## Removal of Engine Cover on 5.7L Engines - MY 2024 - Dodge Durango (WD)

## Water Leak - Backlite - Jeep Gladiator (JT)

## Tappet Kit for the PHEV Fuel Door - MY 2024 and Future - Jeep Wrangler (JL)

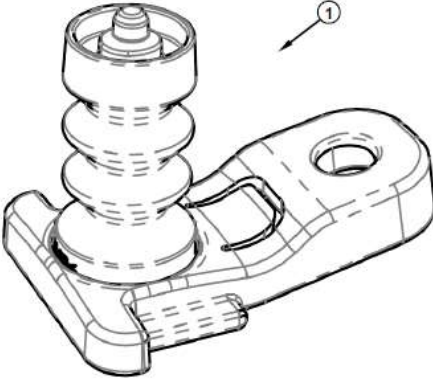
If the JL PHEV fuel door has a missing or broken tappet and/or base, please use the available service PN 68509685AA/B to replace the tappet, rubber boot, and tappet base. Do not replace the full fuel door and housing assembly.

**Issue:** Entire PHEV Fuel Doors housings are being changed instead of just changing/using the Tappet Kit.

**How it happens:** Any issue related to the door opening or not opening where the tappet/tappet base is missing, broken or out of position.

### K6856280 - Jeep PHEV Tappet and Base Service kit

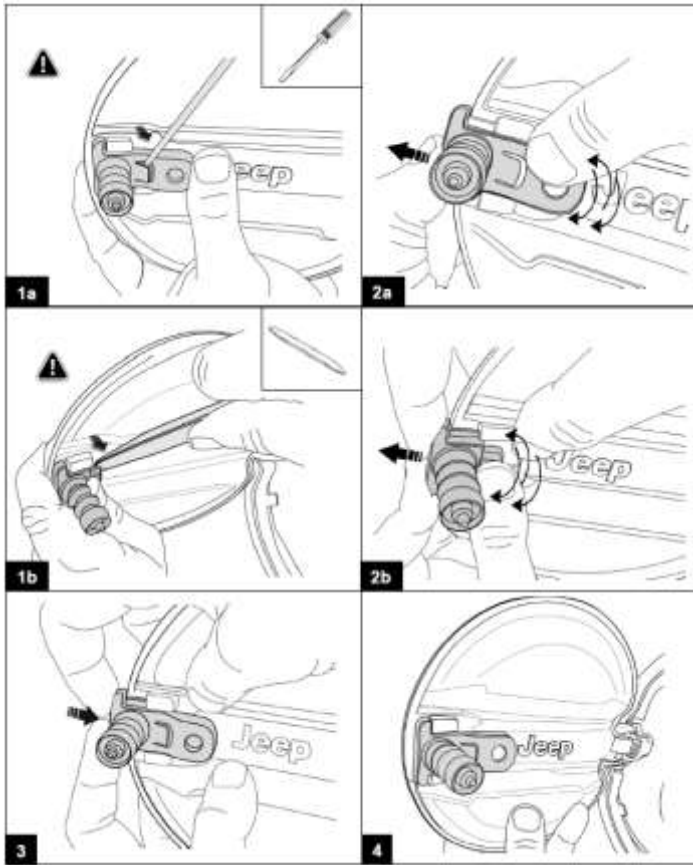
Call Out	Description	Quantity	Service Part (Y/N)	Part Number
1	Tappet with Base ( <i>new style</i> )	1	Y	68509685AB

Install the tappet & base assembly onto the cover. It will be necessary to tap the base into location using a mallet.

**K6856280 - Jeep PHEV Tappet and Base Service kit**

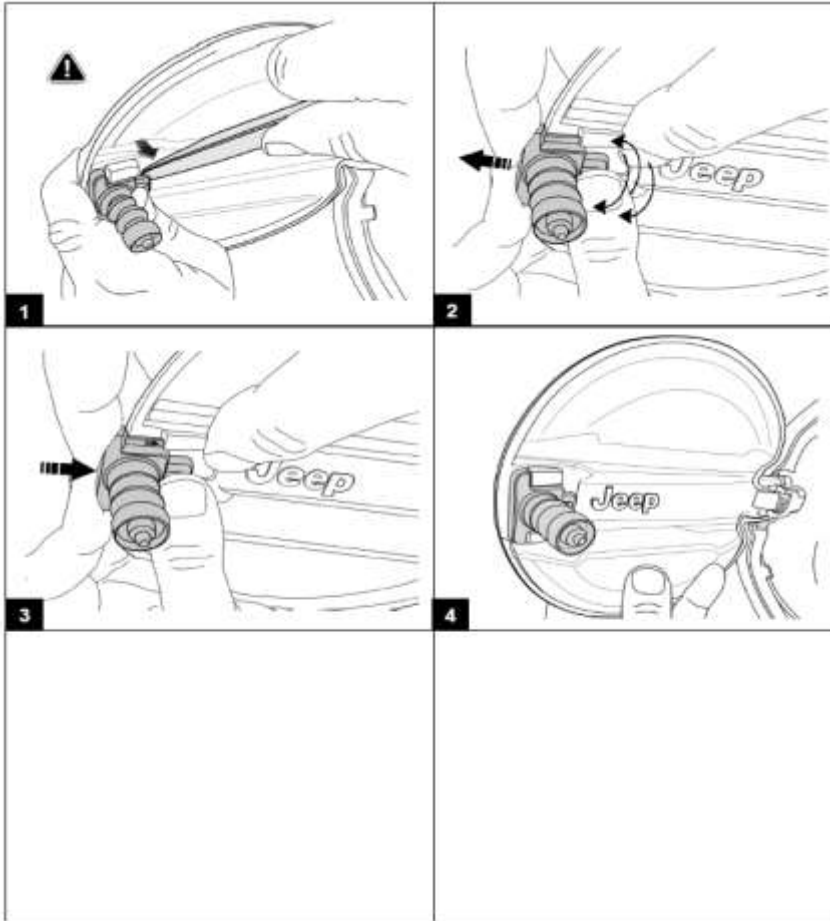
Call Out	Description	Quantity	Service Part (Y/N)	Part Number
1	Tappet with Base (old style)	1	Y	<a href="#">68509685AA</a>

The kit already includes the blue mark (from supplier) across the tappet and tappet base.

Once the correct installation has been verified, apply a blue mark across the back of the tappet and tappet base, using a blue grease pencil.
